**NOTICE TO BIDDERS
ADDENDUM #002**

TO THE BID FOR: B024-6; Y cuj lpi vqp'O kf f rg'Uej qqnDqlgt 'Tgr rægo gpv

ADDENDUM 1

**WASHINGTON MIDDLE SCHOOL
BOILER REPLACEMENT**
MERIDEN, CONNECTICUT

DRAWING NO. **HVAC-2**

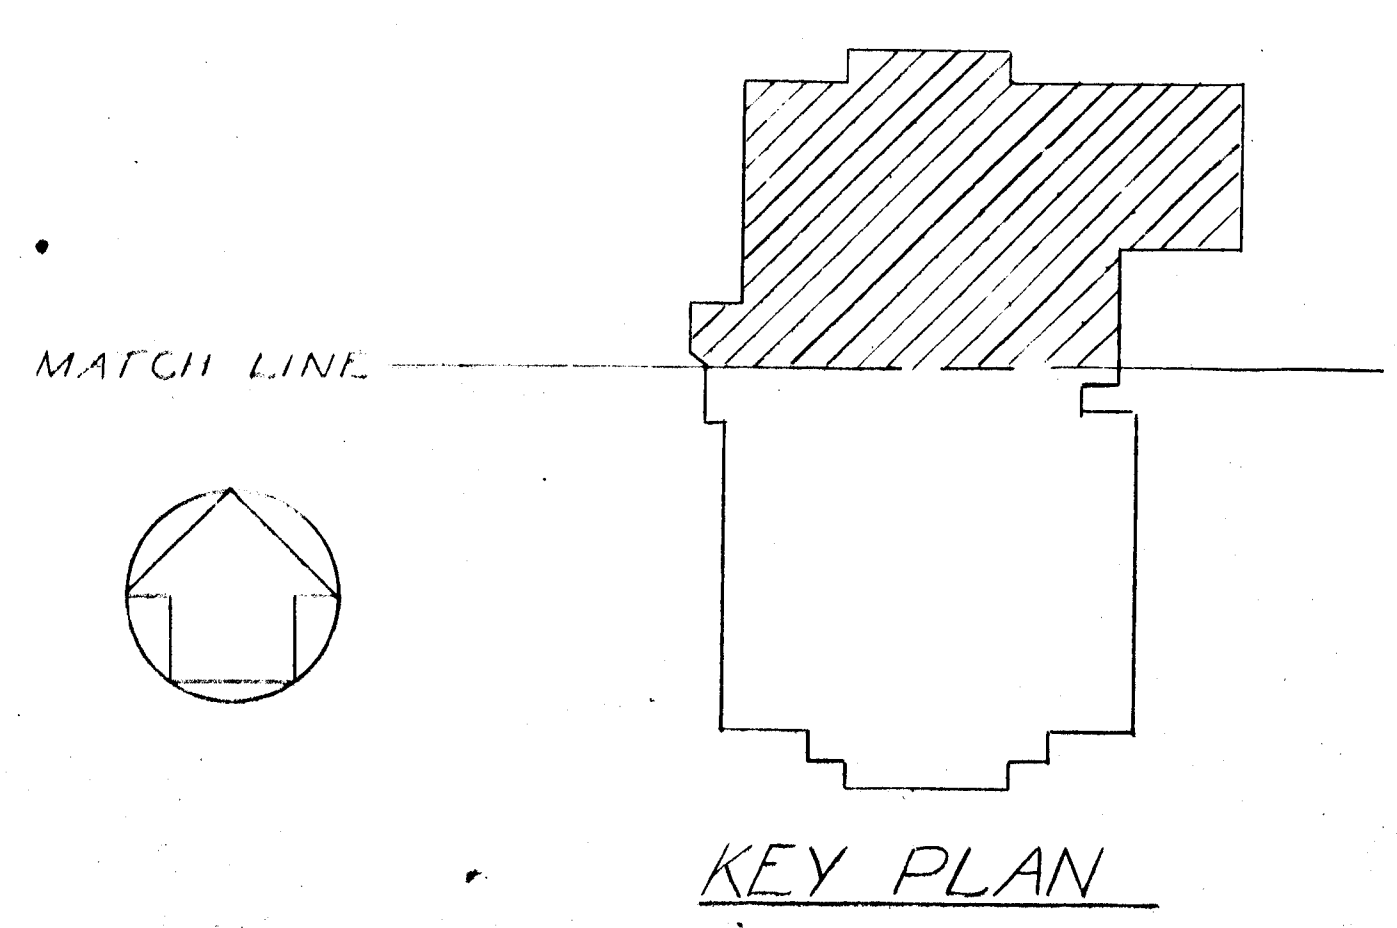
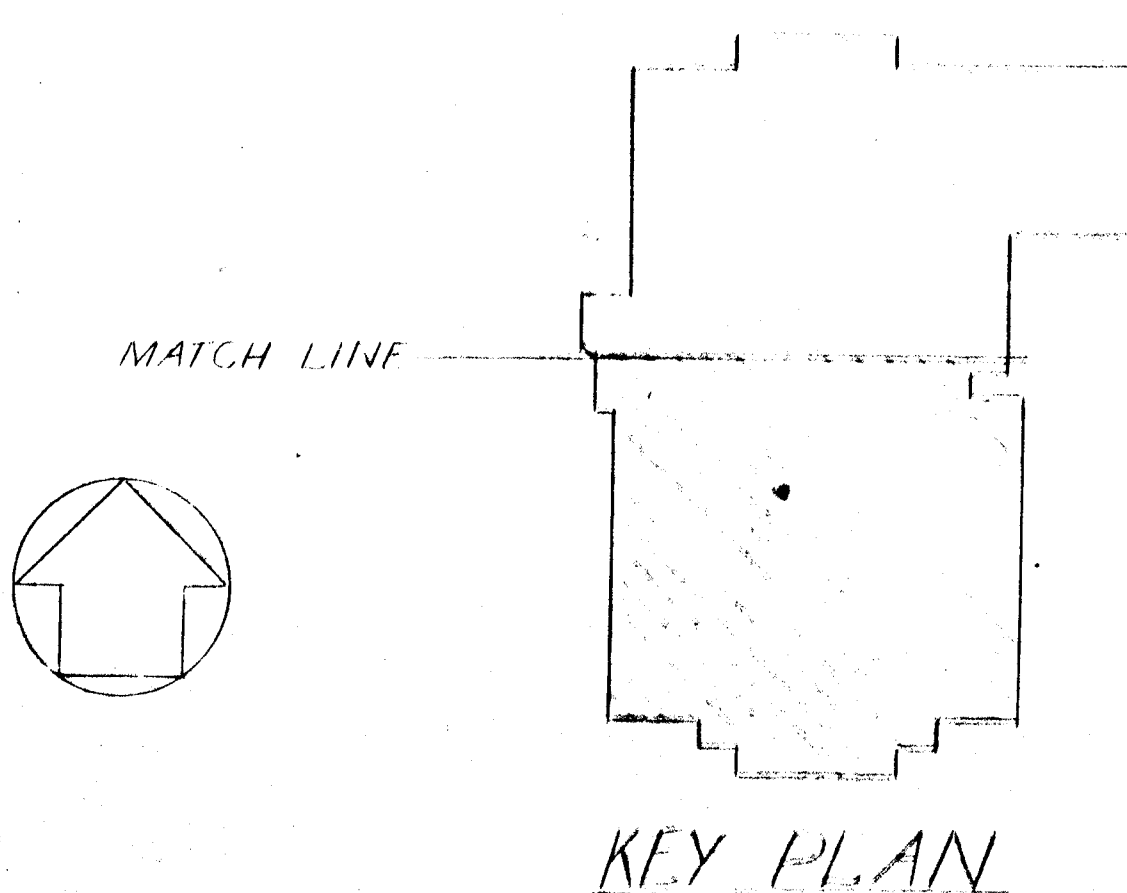
Question: Drawing M0.2, General Mechanical Note #10: "CLEAN AND DISINFECT EXISTING DUCTWORK". Please provide as-builts of existing ductwork so existing ductwork can be quantified.

Answer: Please refer to attached existing drawings for existing duct layout.

DWG. NO.
E0.1

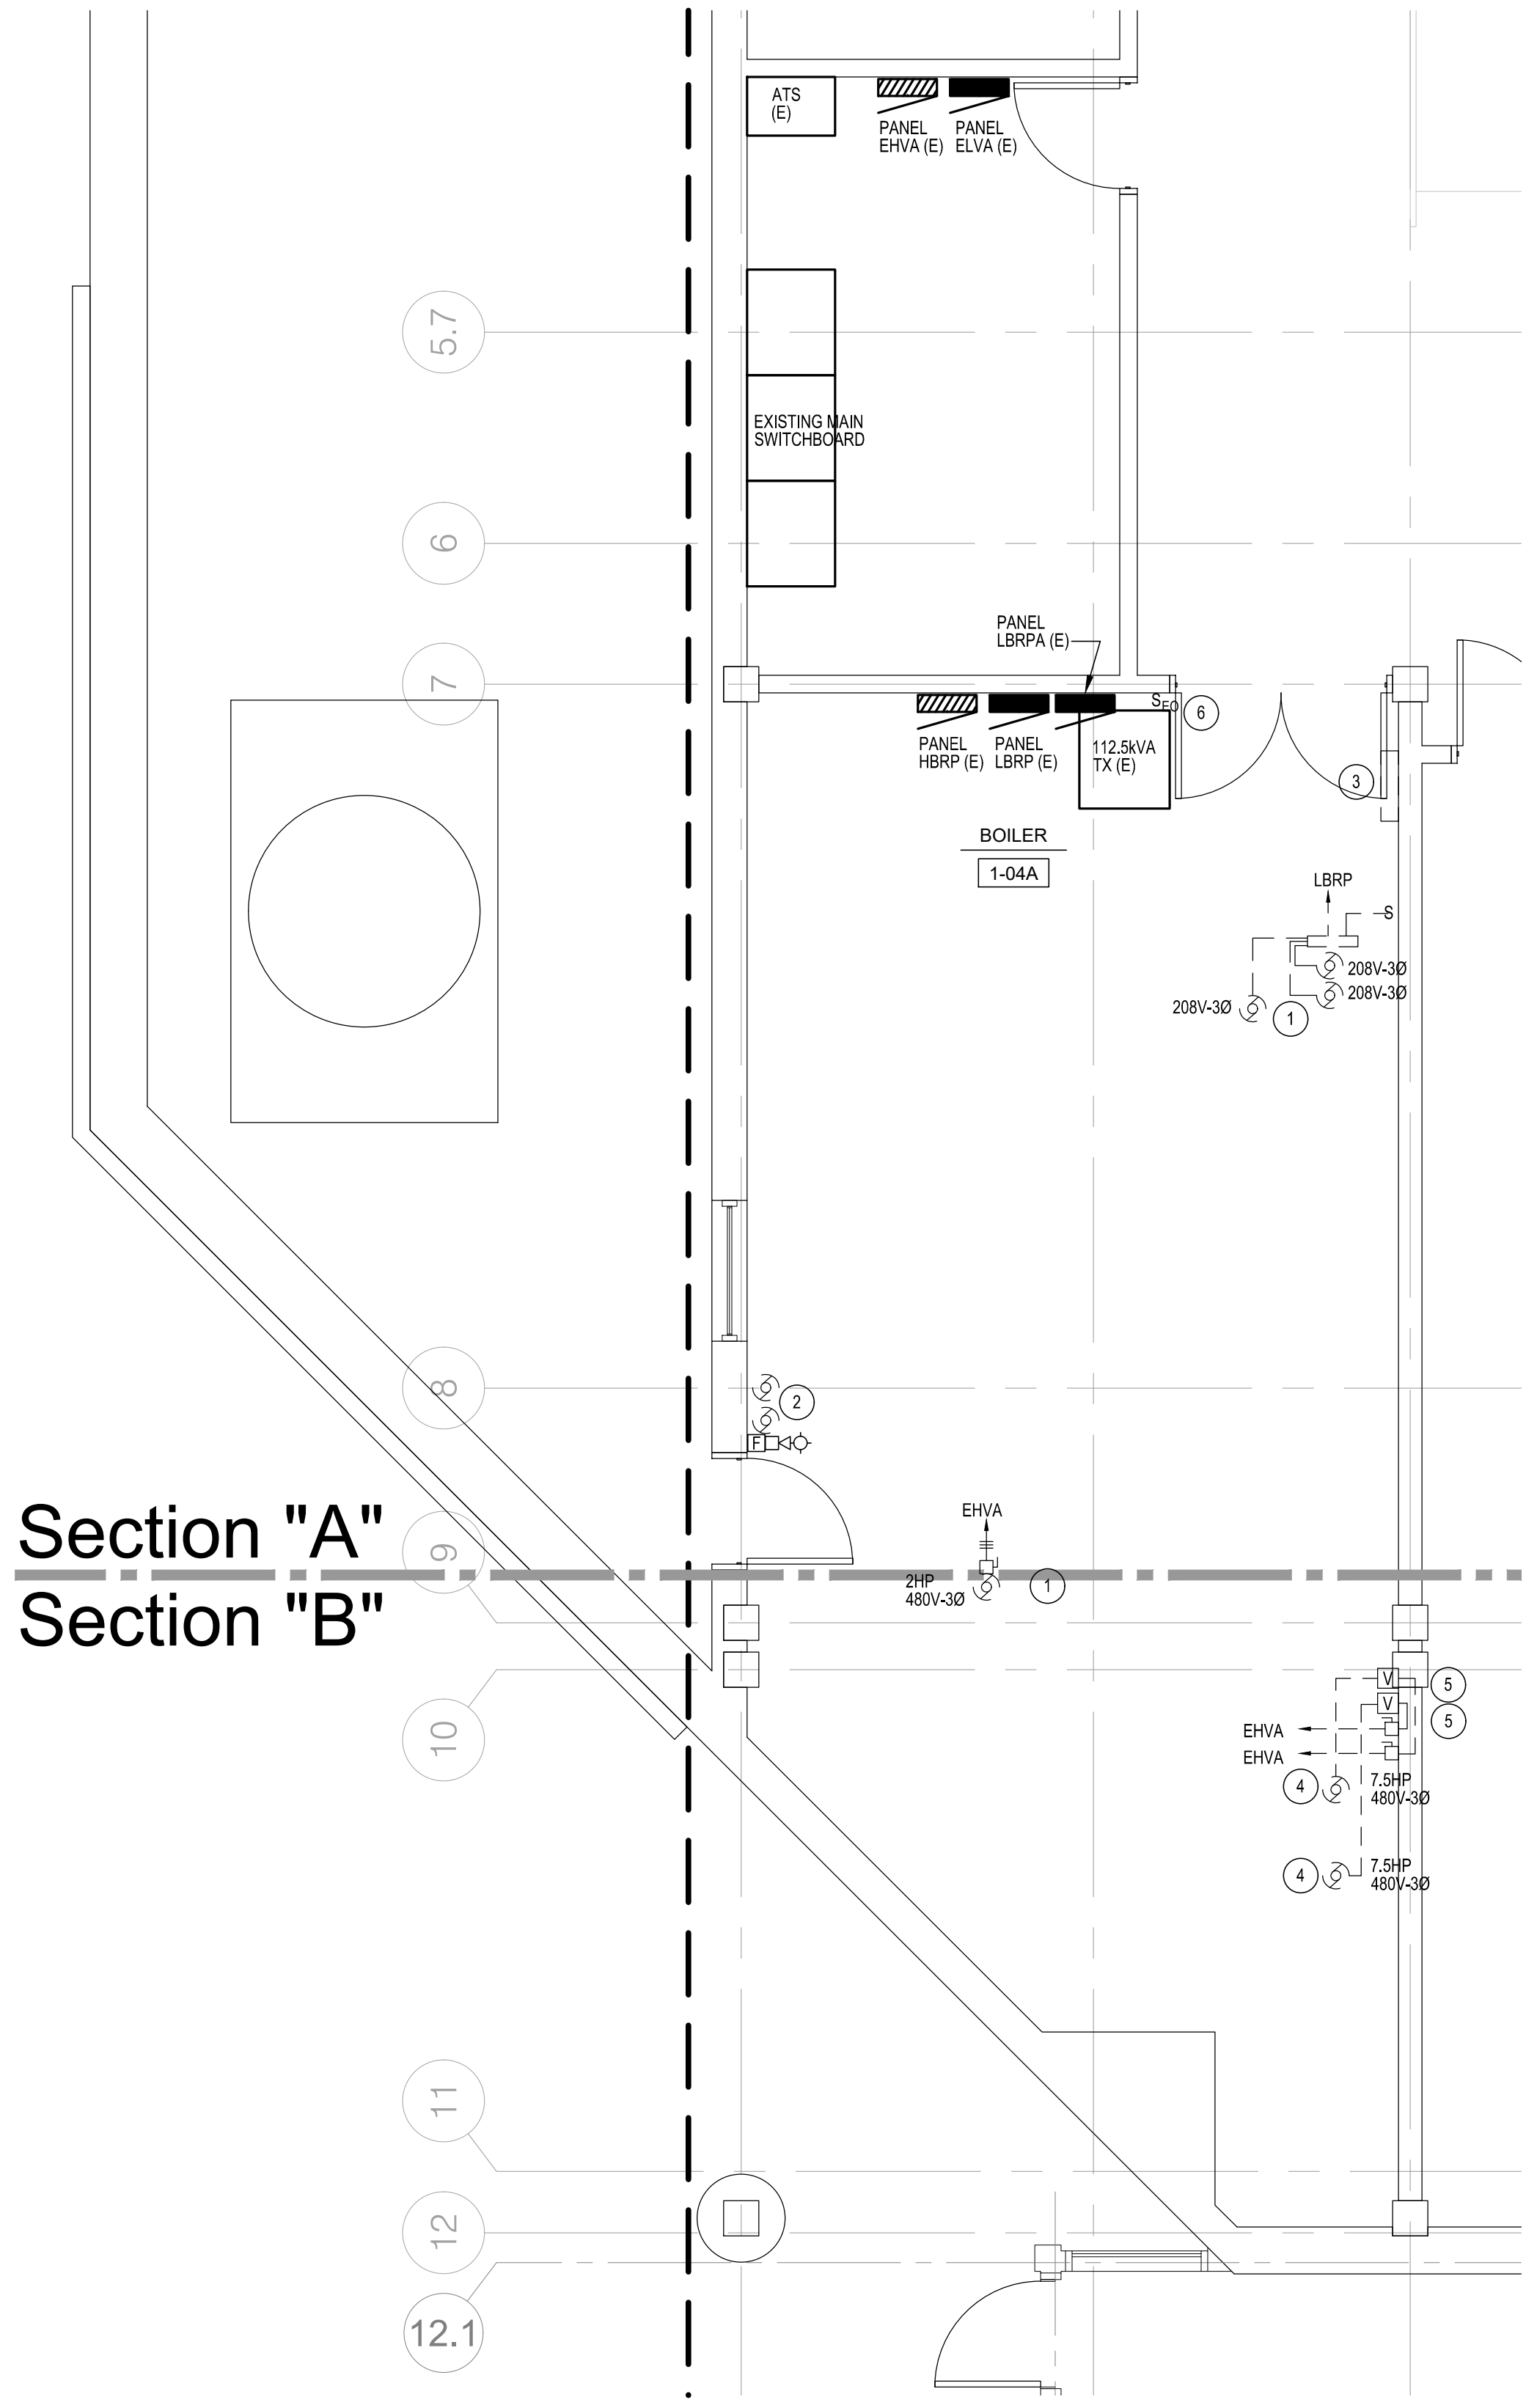
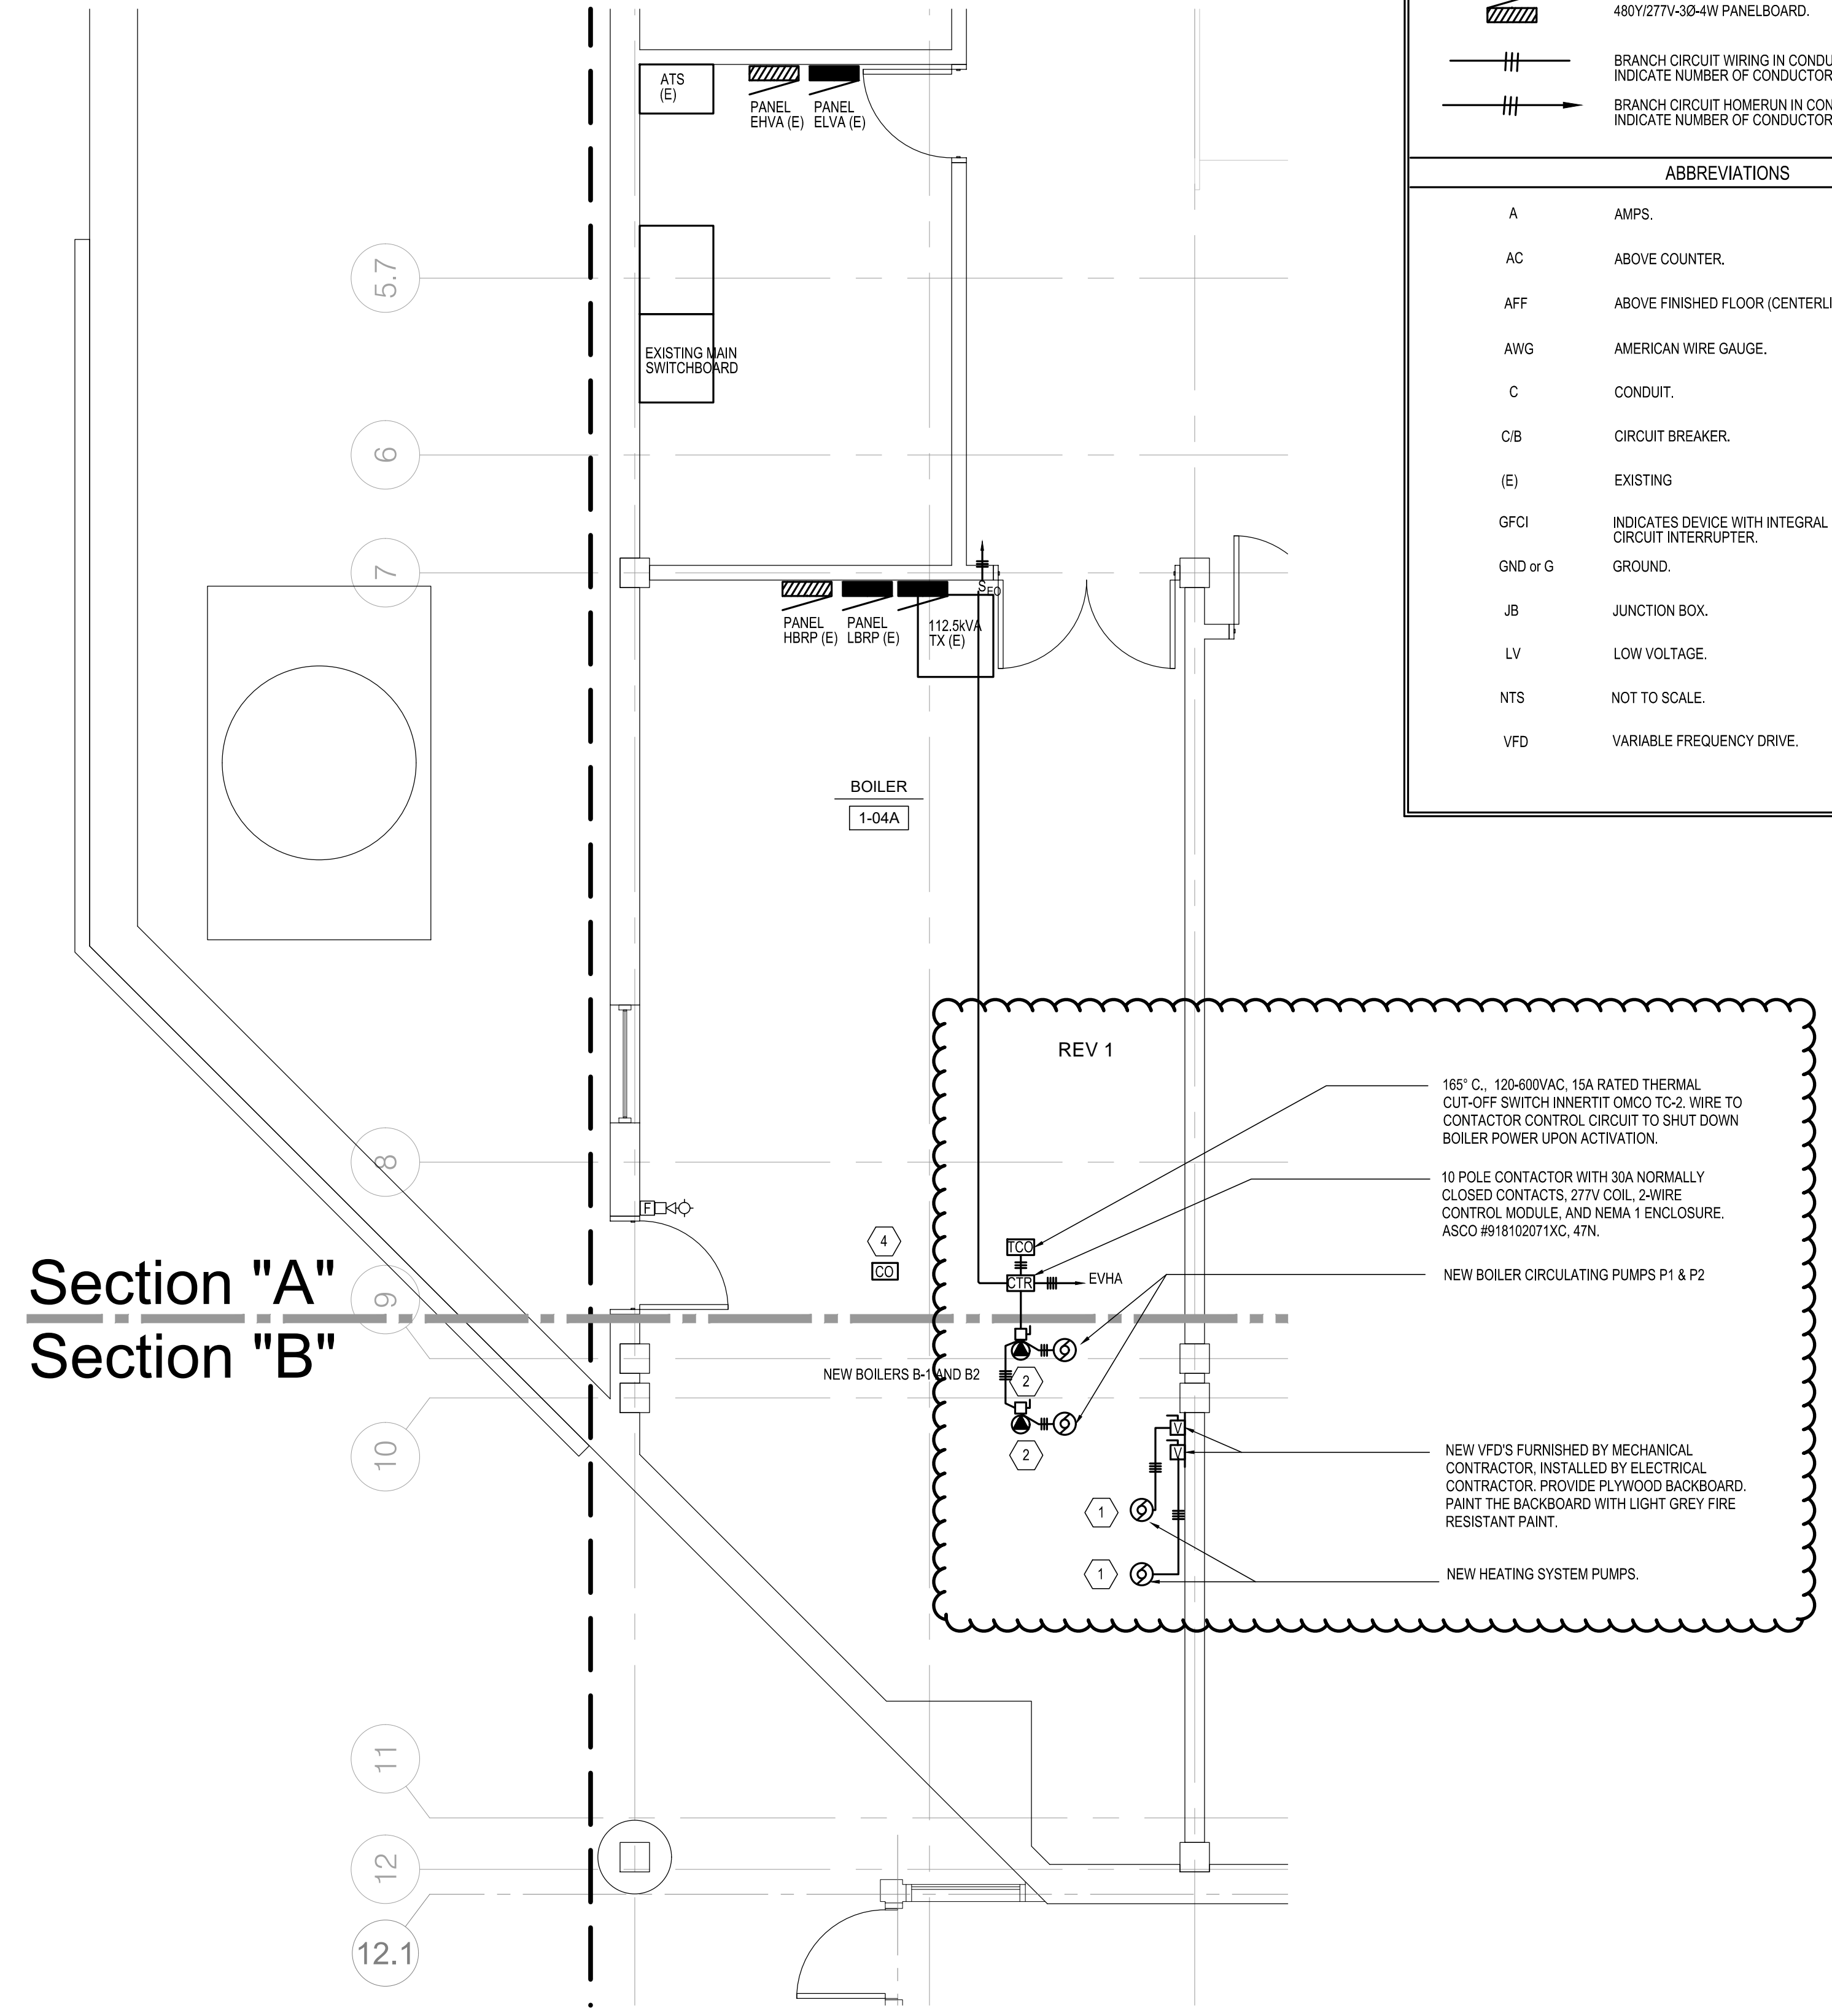
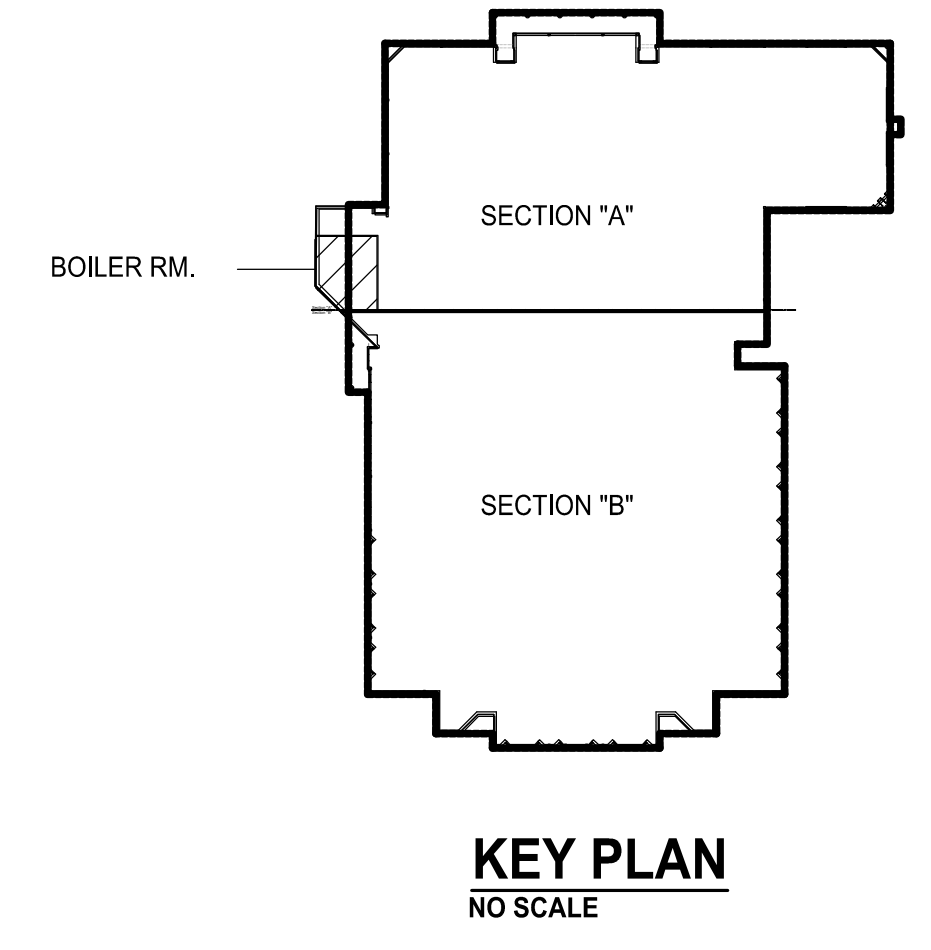
Drawing E0.1: Refer to attached revised drawing

Question: The gas boilers on the electrical plan show them to be 120v single phase while the schedule on M0.2 calls them to be 480v 3 phase. Please clarify.

Answer: Revise boilers to include new 600V 3PH-30A non-fused heavy duty disconnect (for each boiler) in lieu of thermal overload switch as indicated on drawings. Connect to new equipment as required.
